**REMARKS**

09/995,101

Proposed Drawing Corrections

3,204,428

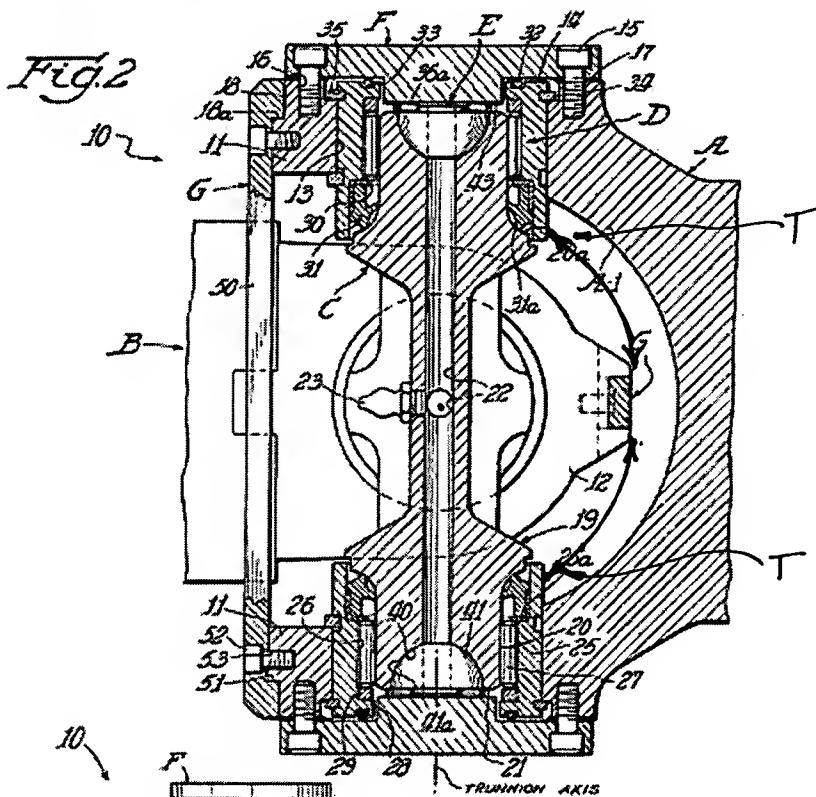
In contrast, Stokely has rotary input and output shafts, each having a pair of arms. Each pair of arms includes a tie means (G) which is an elongated bar (50) having an elongate rectangular cross section. Each positive tie means "extends between opposed arms of each yoke and are adapted to provide a lock for maintaining a predetermined spaced relation between the forked portion arms even during high speed operation." (Column 3, lines 3-7)

Stokely does not show, as is required in the present claim, a restricted swing mechanism pivotally attached to the tines of the yoke to which it is attached, because the tie-means is affixed in place by connector 52. Nor does Stokely show, as is required in Claim 1 of the present application that each internal restricted swing mechanism is sized and shaped to approximate the inner yoke surface of the yoke to which it is not attached, because the tie-means of Stokely is rectangular and inner yoke surface is arcuate. Furthermore, the tie-means of Stokely is "provided to prevent the forked portion arms (sic) from deflecting under centrifugal forces..." (Column 4, lines 11-13) and is not shaped or positioned to contact an inner surface of any yoke surface. Instead, looking to FIG. 1, it is apparent that the tie-means will contact the trunnion at a position illustrated in the figure below by added arrow "T" when the joint is deflected. Therefore, the tie-means of Stokely is not the same structure, nor does it perform the same function as the internal restricted swing mechanism of the present invention. Accordingly, because

FIG. I

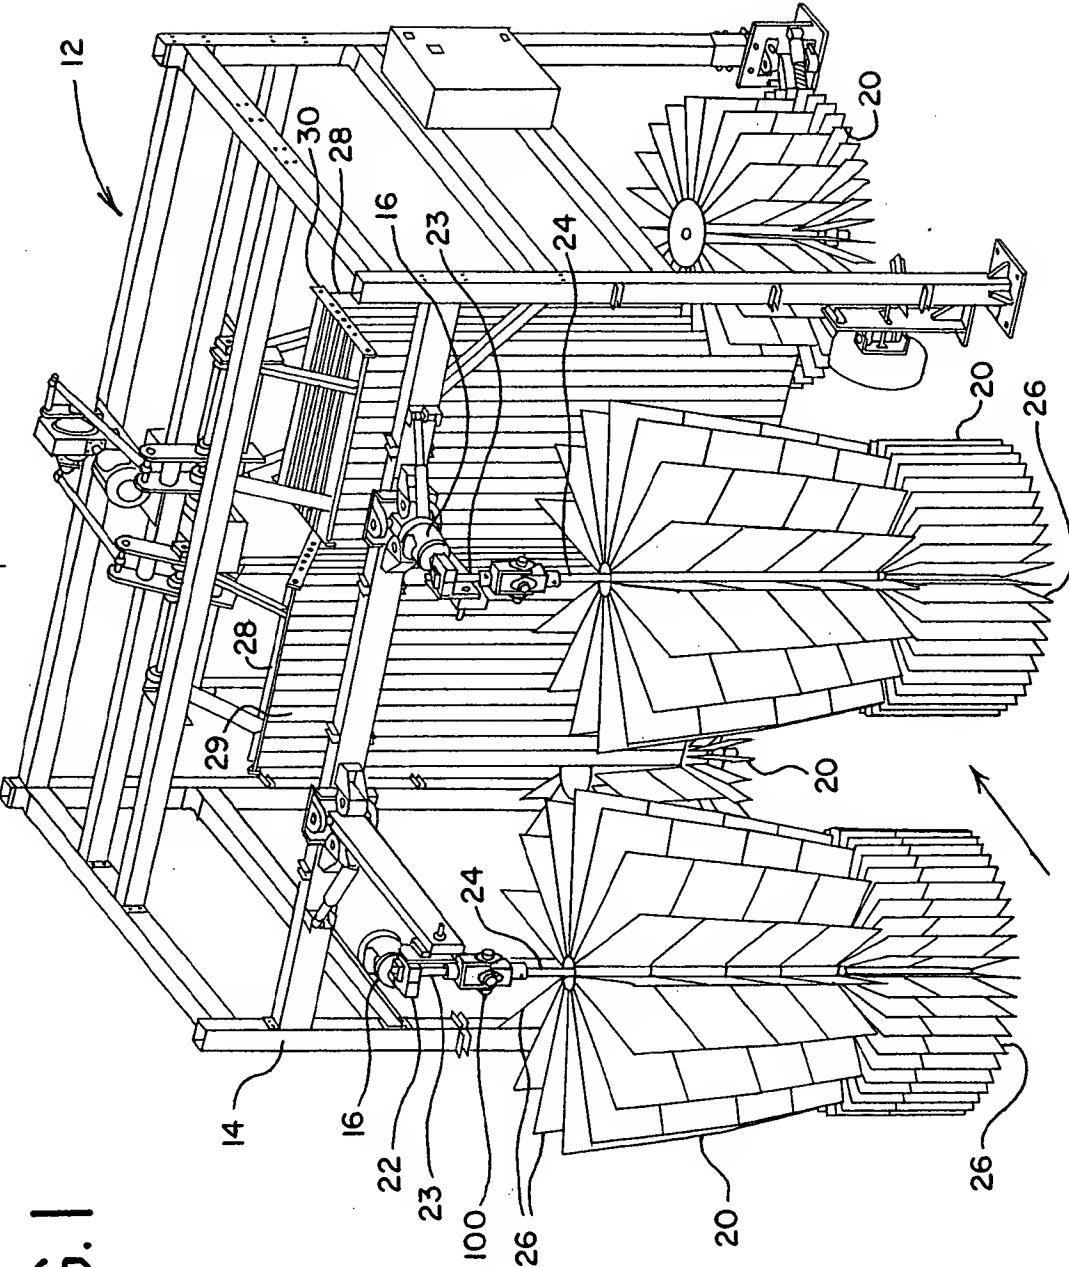
The drawings were also objected to as using reference numerals to indicate more than one element, i.e., 103, 105, 107, 109 and 112. Proposed drawing corrections are submitted herewith which label the elements on the second yoke (104) as 103', 105', 107', 109' and 112'. The formal drawings referred to in the above paragraph incorporate the proposed drawing corrections.
